**Product Change Notification / MFOL-02VEYX739**

CCB 5071 Initial Notice: Qualification of ANAC as an additional assembly site for selected USB3503 and USX3803 device families available in 32L QFN (5x5x0.9mm) package.

**PCN# MFOL-02VEYX739**

# Lead Frame Comparison

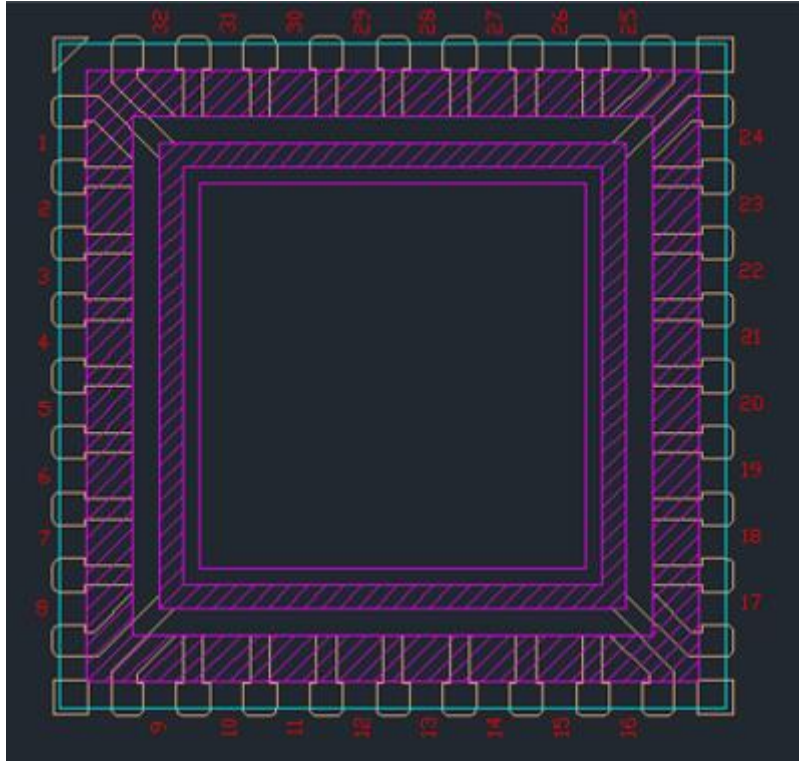
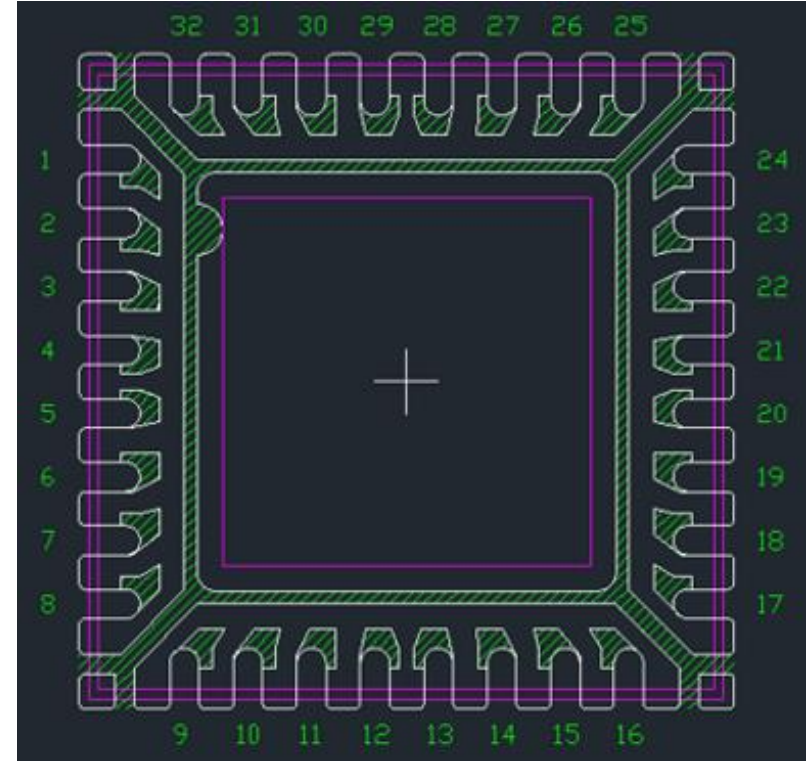
Pre Change	Post Change	
Assembly Site	ASE Inc.	ASE Inc.	Amkor Assembly &

(ASE)	(ASE)	Test (Shanghai) Co., LTD (ANAC)
Wire Material	CuPd	CuPd	CuPdAu
Die Attach Material	EN-4900F	EN-4900F	CRM1085A
Molding Compound Material	G631H	G631H	G631BQF
Lead-Frame Material	C194	C194	C194
Lead-Frame Paddle Size	138X138	138X138	138X138
DAP Surface Prep	Double Ring Plating	Double Ring Plating	Double Ring Plating
